TO BE CONSTRUCTED IN  
**TRACT NO. 30430**

**PRIVATE CONTRACT NO. 9404**

INDEX 273-5-129  
W.S. 62  
3 SHEETS, 5 PAGES

- REVISION NO. 1** 5/8/80
- PAGE 1 INDEX MAP REVISED TO SHOW NEW LIMITS FOR TRACT NO. 30430
- PAGE 2 DELETED SEWER OPEN CREST DRIVE BETWEEN STA. 25+51.89 AND 30+30.00.  
REVISED SEWER PLAN C PROFILE OPEN CREST DR. BETWEEN STA. 24+25 AND 25+43.89
- PAGE 3A DELETED SEWER IN BROCCUS PLACE.  
REVISED SEWER PLAN AND PROFILE GROVE-PARK DR. BETWEEN STA 0+00.00 AND 6+50.00, ALONG THE NORTH SIDE OF GROVE-PARK DR. DELETED LOTS 23 THRU 33 INCL. TR. 30430 AND REPLACED WITH LOTS 47 THRU 55 INCL. TRACT 30721.
- PAGE 3C REVISED SEWER PLAN AND PROFILE GROVE-PARK DR. BETWEEN STA. 0+00 AND 1+15.00.
- PAGE 4B DELETED SEWER IN MARJORAM COURT.
- PAGE 5 REVISED SEWER PLAN AND PROFILE GINGER WAY BETWEEN STA. 0+00 E. 2+72.10.  
DELETED SEWER BETWEEN STA 2+72.10 AND 6+50.00.  
APPROVED: *Ralph David Stewart 12/29/77*  
OFFICE OF COUNTY ENGINEER

48124

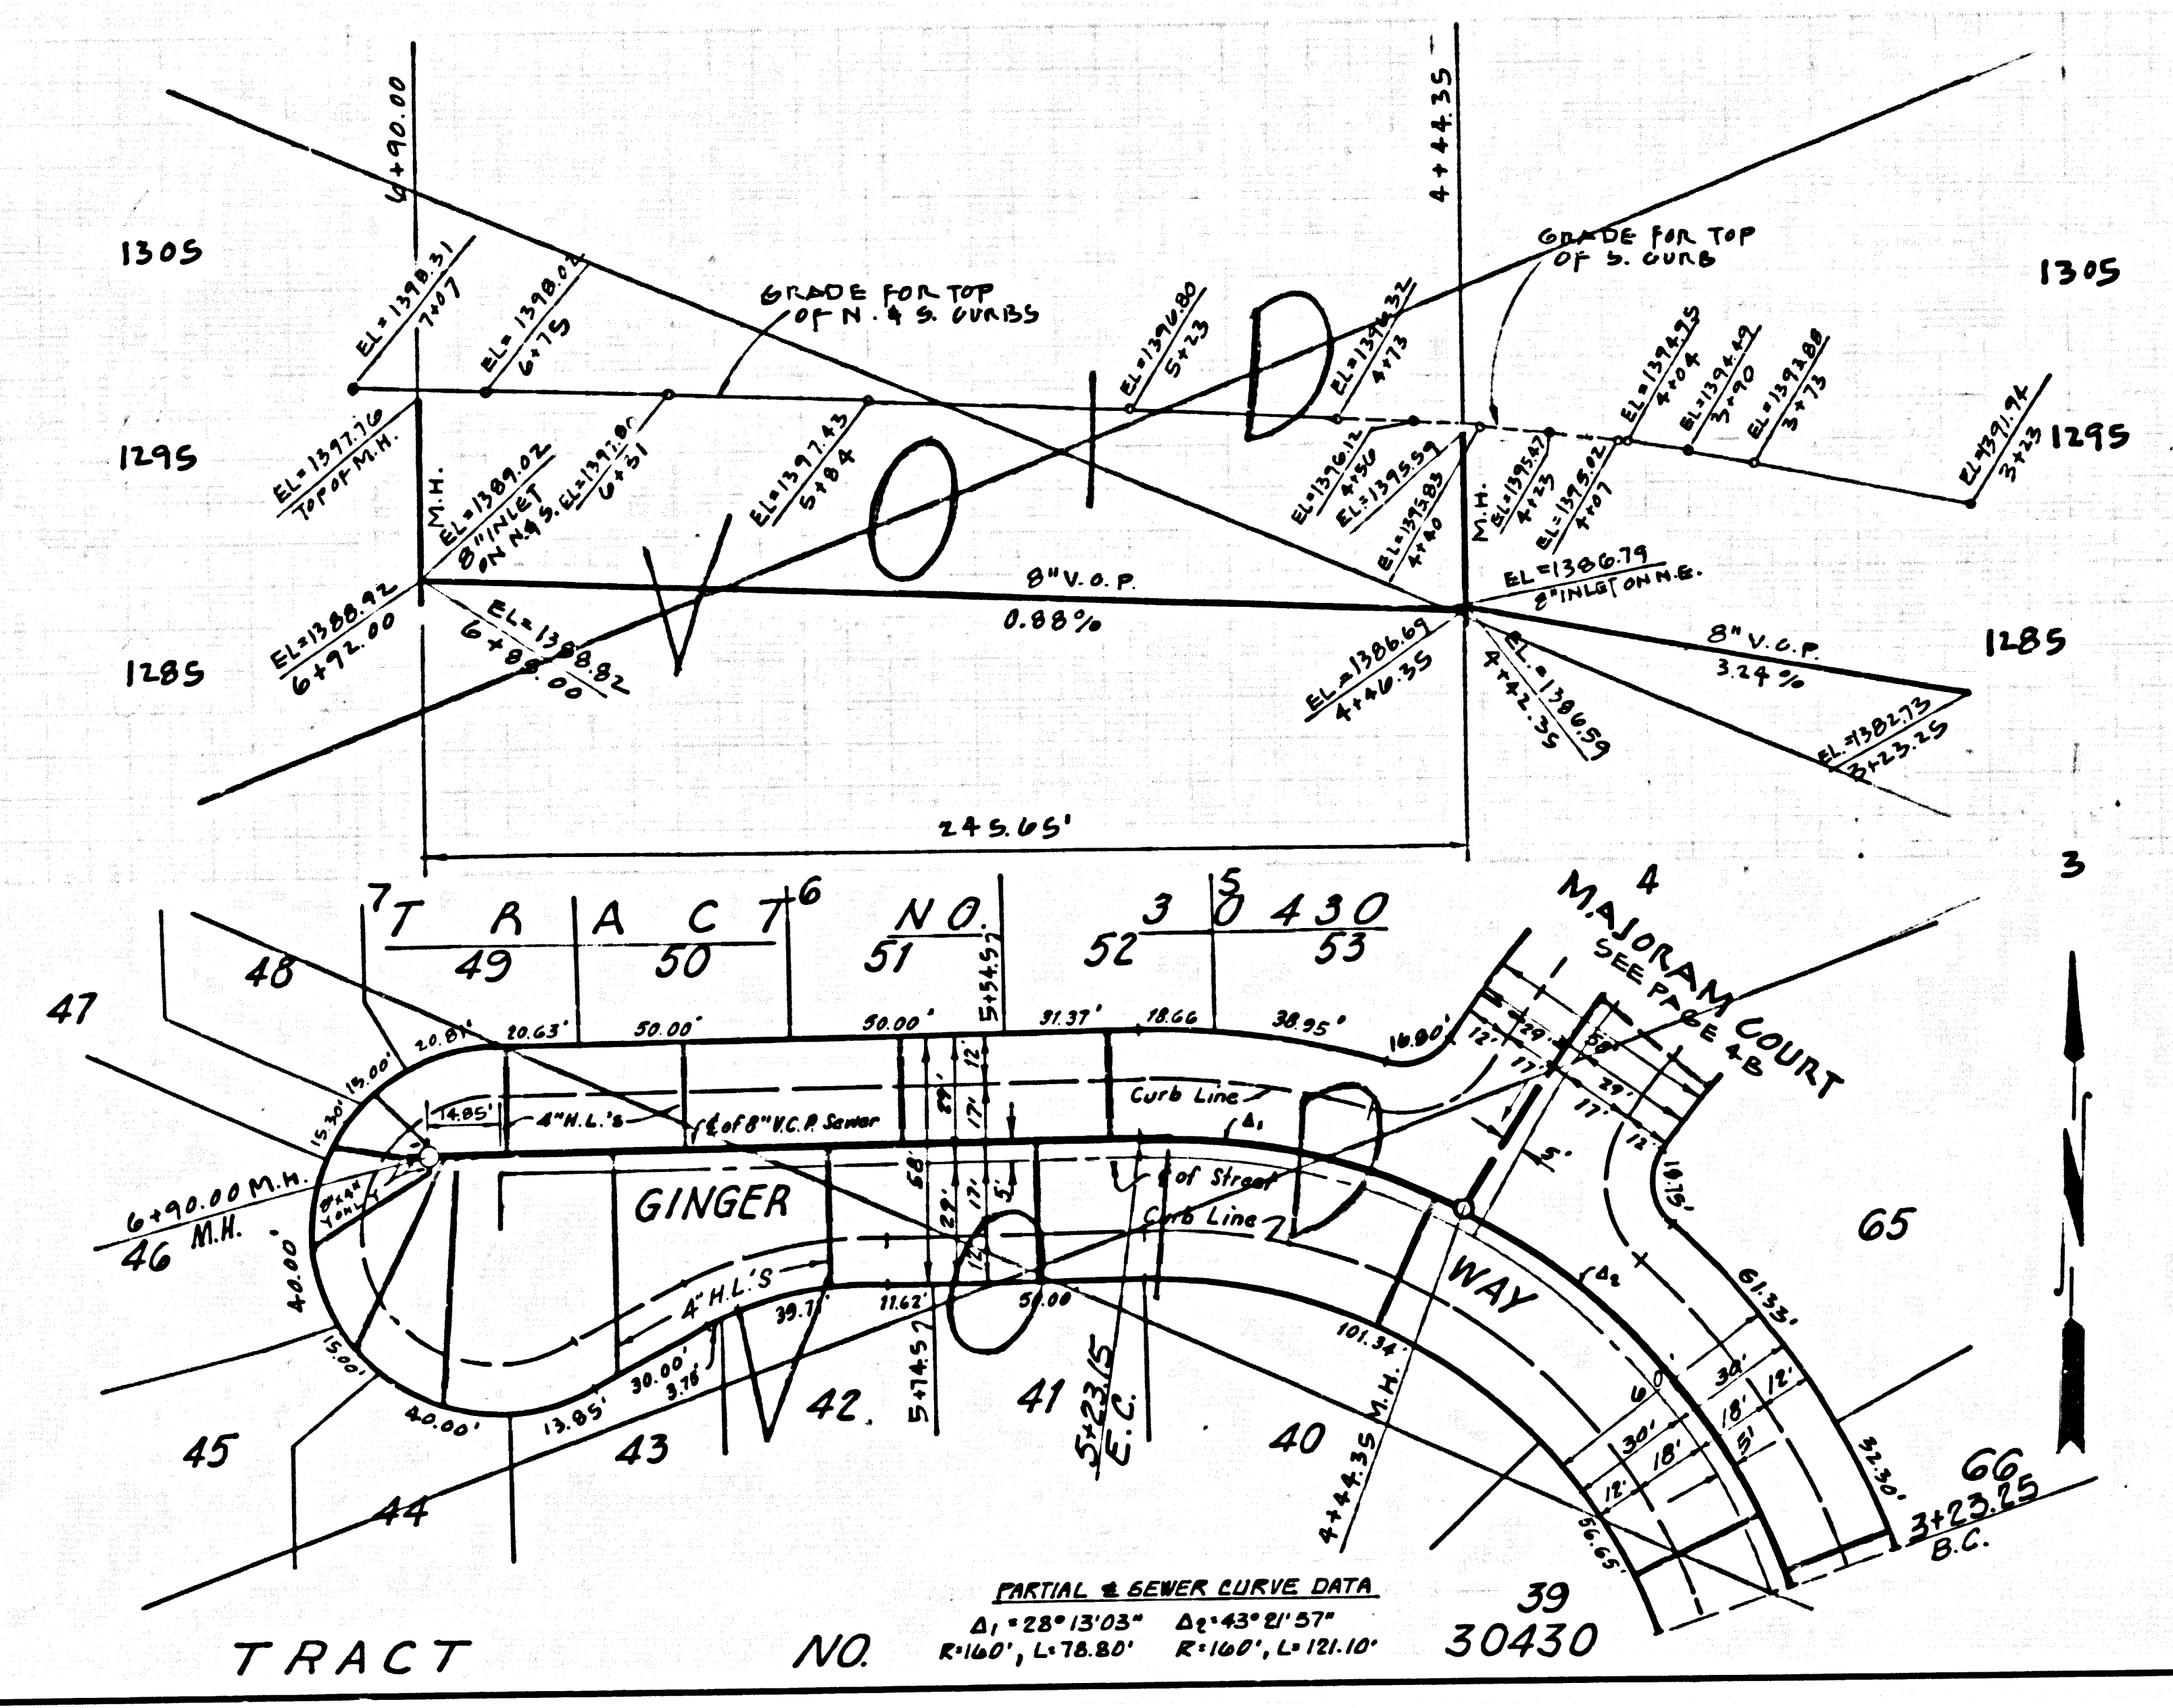
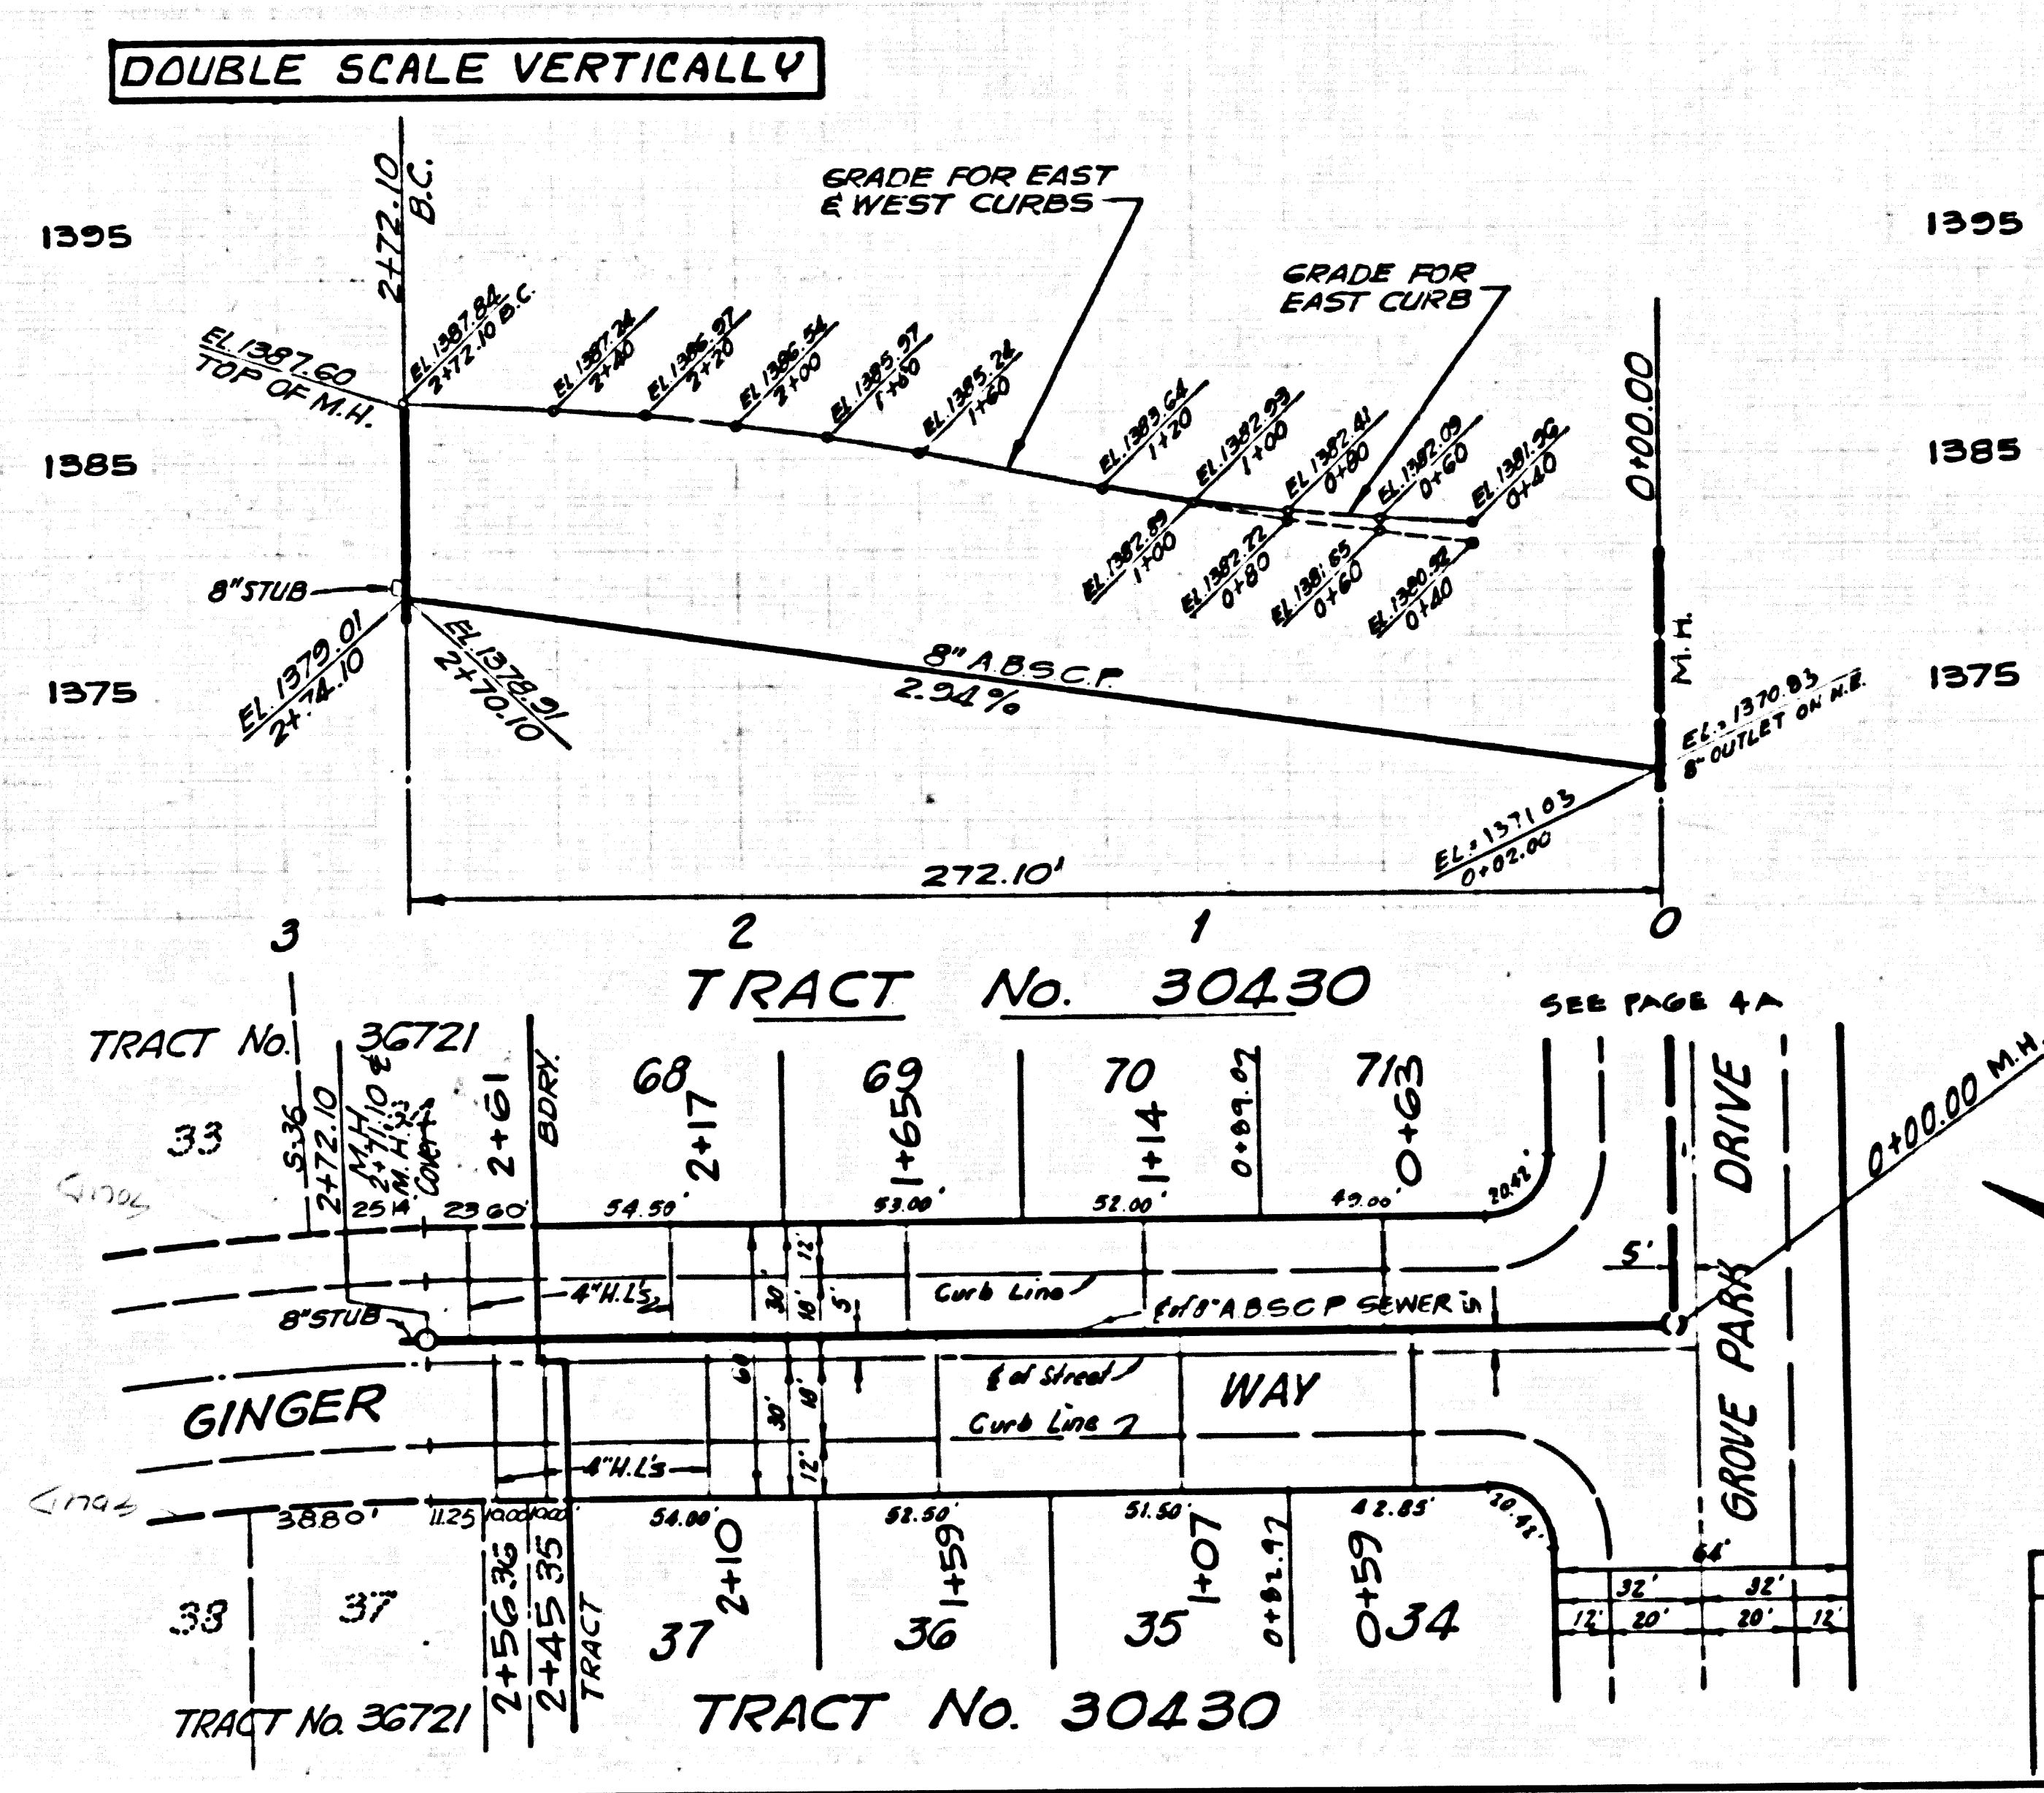
No.	REVISION	BY	CHK.	DATE
1	REVISED TO SHOW 10' MIN. COVER	M.P.S.	TE	5/18/80
2	OWNER HAS REVIEWED PLAN & APPROVED FOR CONSTRUCTION
